REMARKS

This is intended as a full and complete response to the Office Action dated December 8, 2004, having a shortened statutory period for response extended one month to expire on April 8, 2005. Please reconsider the claims pending in the application for reasons discussed below.

ANNOTATED SHEET
AMAT/2622.D1/CMP/ECP/RKK
10/630,185
JULY 29, 2003
APPLIED MATERIALS, INC.
ELECTRO-CHEMICAL DEPOSITION CELL
DORDI, ET AL.

Fig. 8

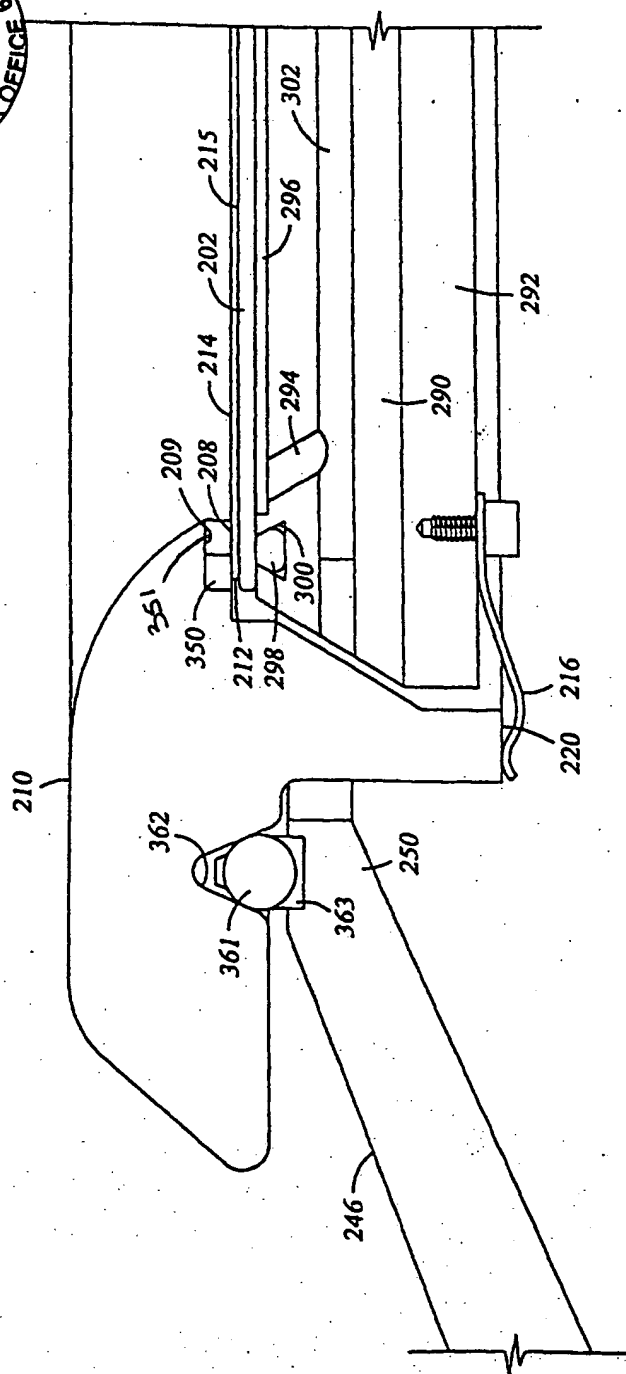
One attached sheet of drawings includes changes to Figure 8. This sheet replaces the original sheet including Figure 8. In Figure 8, element 351 has been added.

In Figure 8, element numeral 351 has been added.

Fig. 12

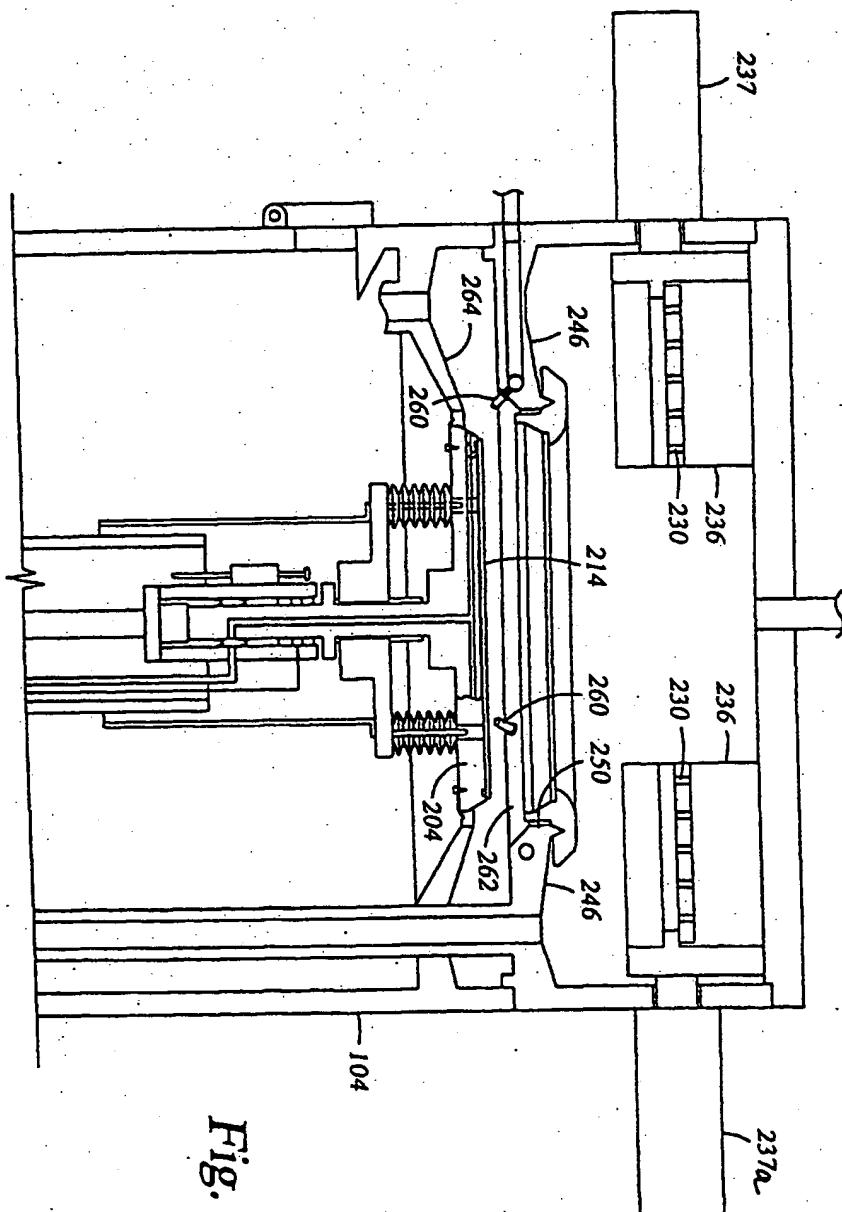
One attached sheet of drawings includes changes to Figure 12. This sheet replaces the original sheet including Figure 12. In Figure 12, element 237 has been renamed 237a.

In Figure 12, element numeral 237 has been renamed 237a.

FIG. 13

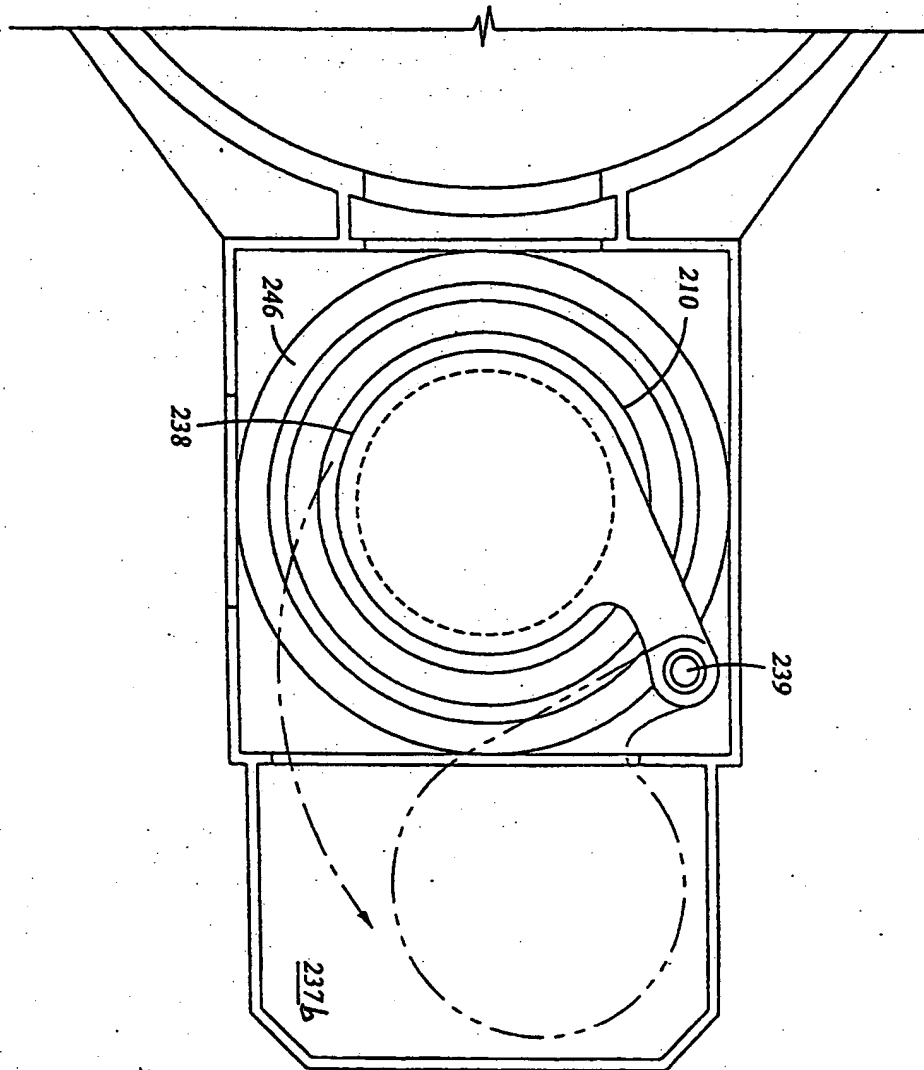
One attached sheet of drawings includes changes to Figure 13. This sheet replaces the original sheet including Figure 13. In Figure 13, element 237 has been renamed 237b.

In Figure 13, element numeral 237 has been renamed 237b.

Fig. 16

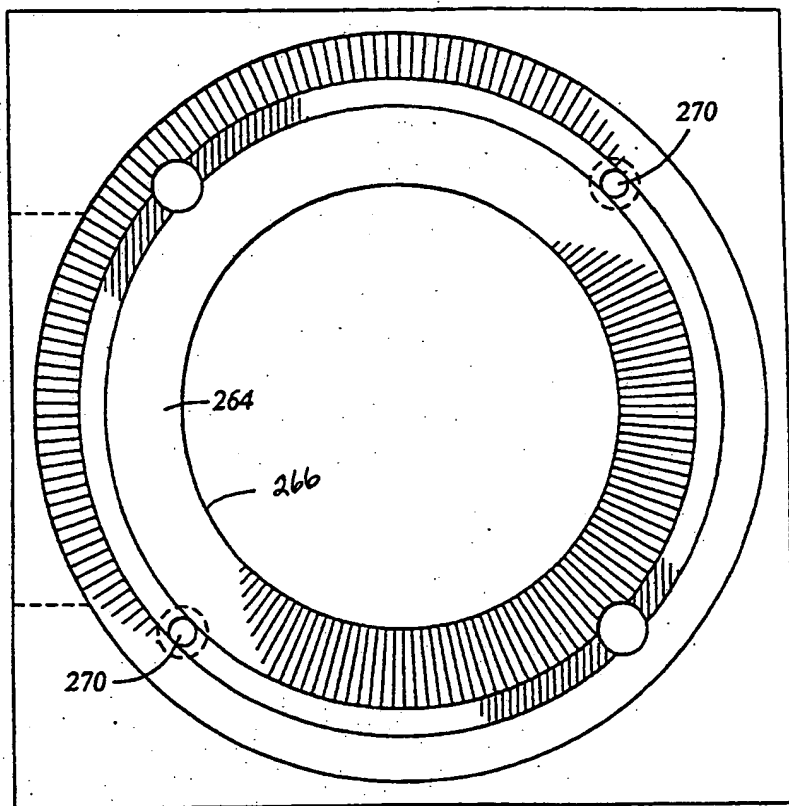
One attached sheet of drawings includes changes to Figure 16. This sheet replaces the original sheet including Figure 16. In Figure 16, element 266 has been added.

In Figure 16, element numeral 266 has been added. Claims 9 and 24 have been cancelled without prejudice by Applicant. Claims 1 - 27 stand rejected by the Examiner. Claim 28 has been added. Reconsideration of the rejected claims is requested for reasons presented below.
